Comments on #FSP-26-0013 - Planning & Zoning: Final Subdivision Plat

Application Number: #FSP-26-0013
Application Type: Final Subdivision Plat
Date: September 3, 2026
Address: 0 AMAZON TRL

FINAL SUBDIVISION PLAT
OF
THE PRESERVE AT MOODY FARM
PHASE 1
(LOTS 1-17)

SHEET
7
OF
7

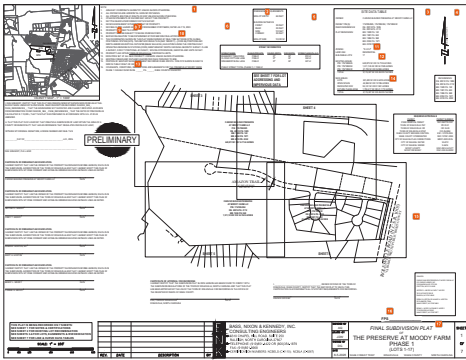
2026-08-05 25154 MOODY FARM SUBDIVISION PH1.pdf · Page 7 · August 21, 2026, 7:45am

Would really prefer this be on SHeet 1 or at least 2 - this is vital, "the reason I came to look at the plat" type of info. Line and curve tables are great as the last sheet(s), not this info.

Pls provide a lighting plan sheet.

As a Seperate doc - provide a Street Lighting pole exhibit and tell staff how many street light poles are in ROW's in this phase/FSP - Staff will invoice the one-time \$650 per pole fee upon knowing and confirming this number.

Spelling error - Cemetery

48 Michele Raby
Pls correct Rolesville spelling on lot address table

2026-08-05 25154 MOODY FARM SUBDIVISION PH1 - COVER SHEET.pdf · Page 1

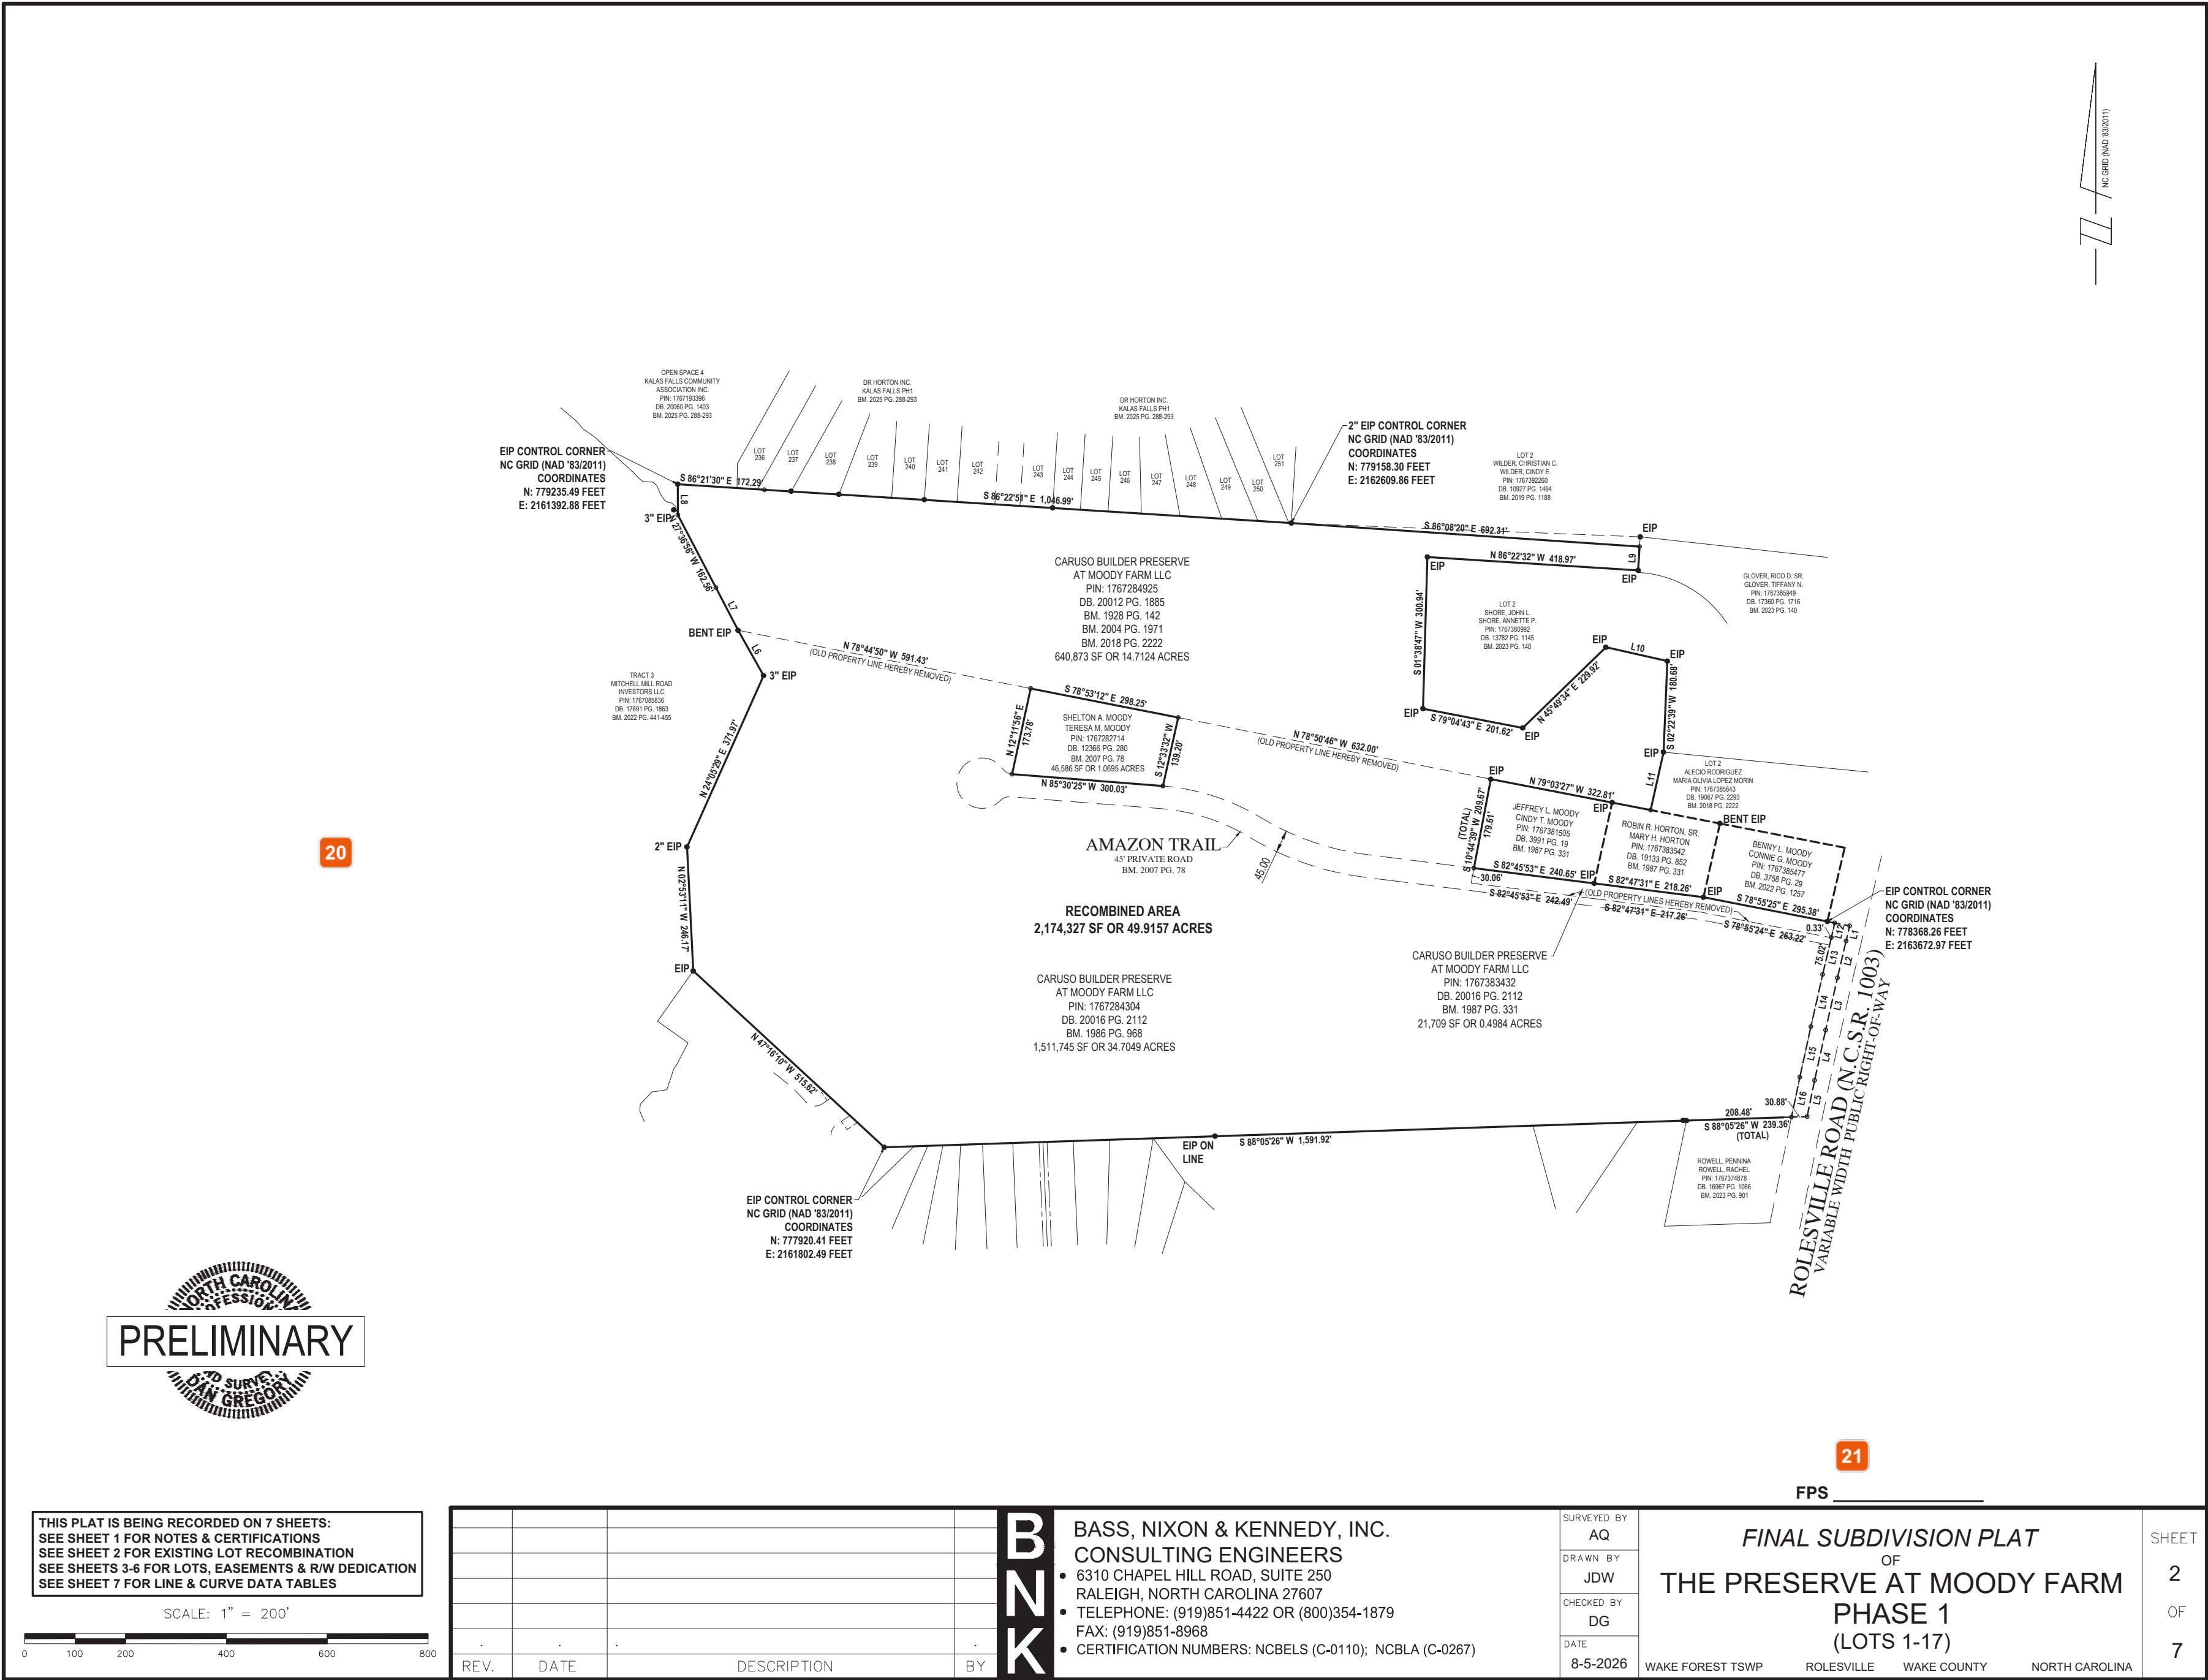
Michele Raby
Please add the adjoining property owners list; see the FSP example sheet for reference: <https://www.rolesvillenc.gov/sites/default/files/uploads/fsp-coversheet-example-2026.06.16.pdf>
- 2

Michael Elabarger
please re-order/re-stack - Lot width, lot size, then the building setbacks.
- 3

Michael Elabarger
The file uploaded for the Approved (Signed) Zoning Conditions appears to be a duplicate of the Final Subdivision Plat Checklist. Please upload the correct signed zoning conditions document.
- 4

Tim Beasley
See Austin's comment. Please submit through Raleigh's Permit and Development Portal. Please email us if you have any questions. Thanks.
- 5

Michele Raby
Please add a phasing table.
- 6

Austin Bain
Submit to Energov for COR review.
- 7

Michele Raby
Please add UDO to Note 8.
- 8

Michael Elabarger
Note 8 - please add also (LDO = RH-CZ) because the zoning map now and forever will call this property RH-CZ not R3 though that is what it was zoned to under the UDO.
- 9

Michael Elabarger
Note 9 - why at this point in time, this is in question ("may") - why is this not known now -this is the final document to be recorded forever...can this be clarified Is/Is not ?
- 10

Michael Elabarger
Note 10 - what 'final approval' is this? Confirm that decision point has not yet occurred.
- 11

Michael Elabarger
see other comment about Zoning - be consistent.
- 12

Michael Elabarger
Clearly add the Acreage of just this phase - it would actually be great if you could just break down the 49.x acres by each of the phases - maybe BOLD the current phase being platted, but we could see the big picture - the phased pieces should equal the sum (49.x acres). thanks.
- 13

Michele Raby
16. Please add covenants DB & PG when recorded. before final signatures are obtained.
- 14

Michael Elabarger
As noted in emails - all of this data is for the entire subdivision and not just this 1st phase.
- 15

Michael Elabarger
PR 22-01 (preliminary plat) had some great cover sheet notes - why are they not carried forth on this final plat? Please look at them and add what is worth saying - reminder that this FSP is what will be looked at by many viewers, "forever" - almost no one will ever view the Prelim Plat (slightly more may look at the CD's). thank you.
- 16

Michael Elabarger
Revise/Complete - FSP-26-0013
- 17

Michele Raby
Pls add address.

R:\2025\25154 - Preserve at Moody Farm (Rolesville)\SURVEY\25154\CARLSON\dwg\25154 MOODY FARM SUBDIVISION PH1.dwg, SHEET 2, 8/5/2026 2:02:16 PM, jonathan.weaver

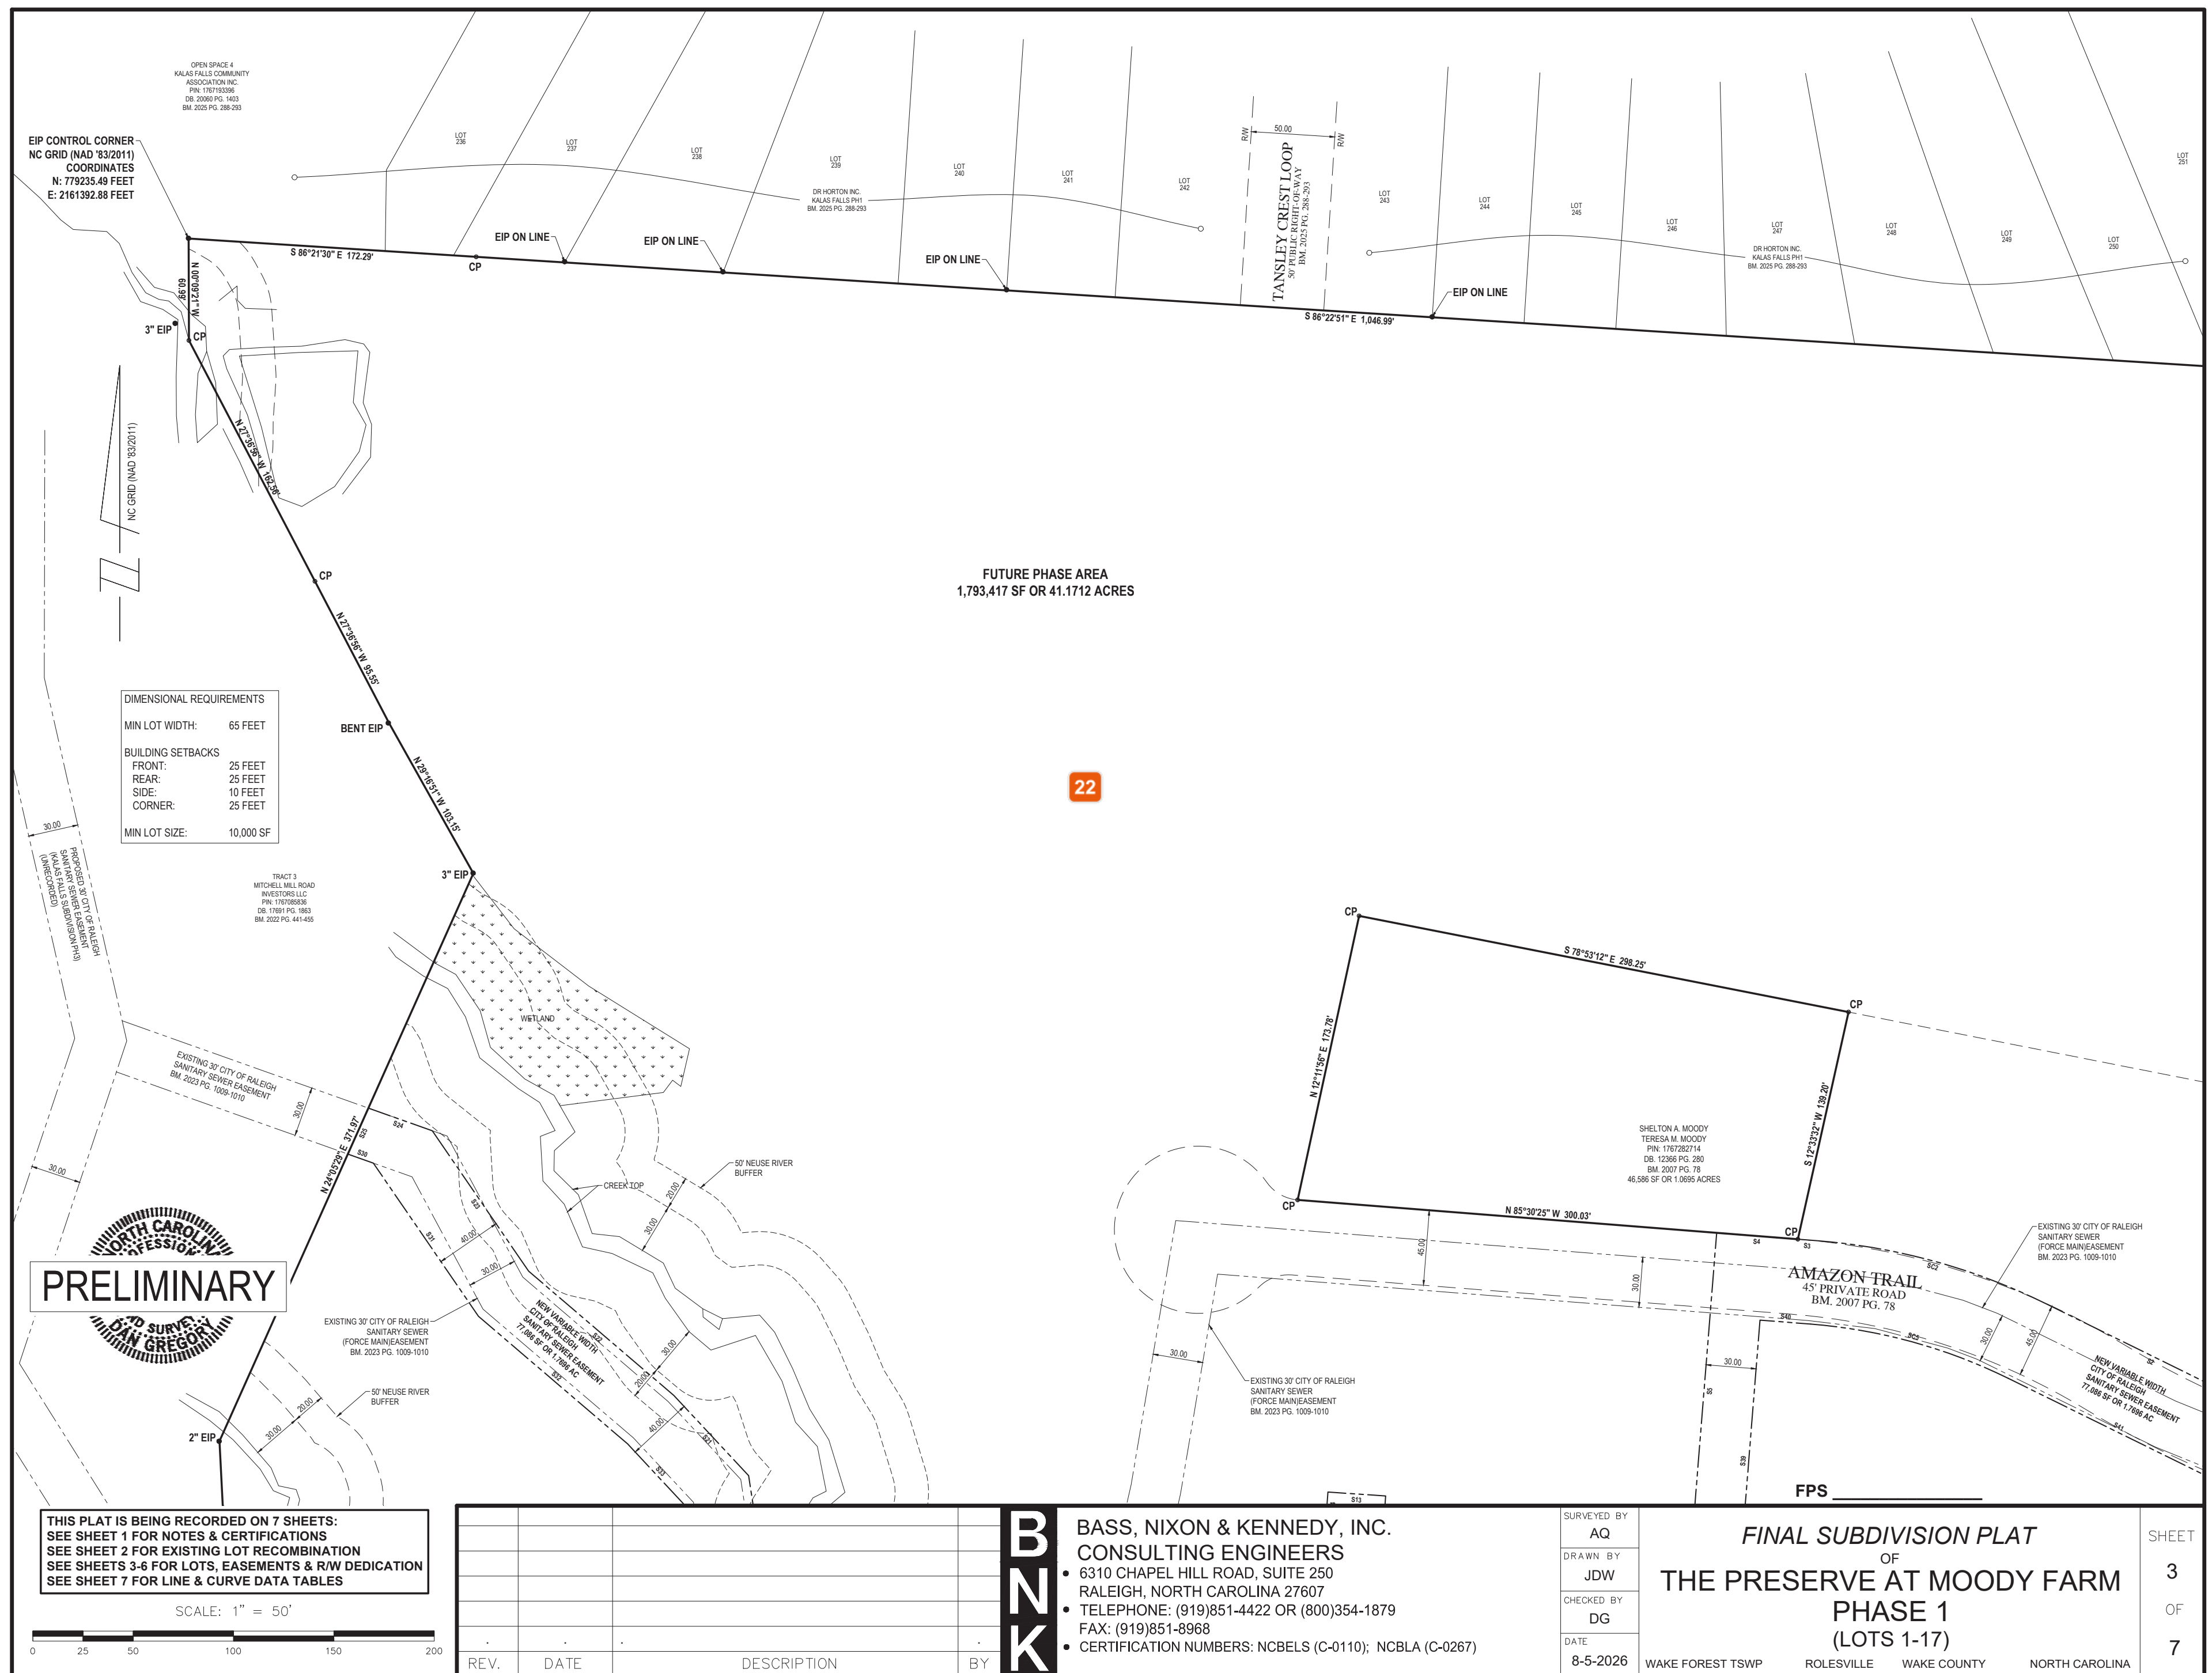
is this sheet necessary? it's the whole subdivision - it's a sheet like this that somewhat makes this plat confusing as to the scope of what it is (Phase 1, just 17 lots) and what it is not.

revise/complete - FSP-26-0013 on all sheets
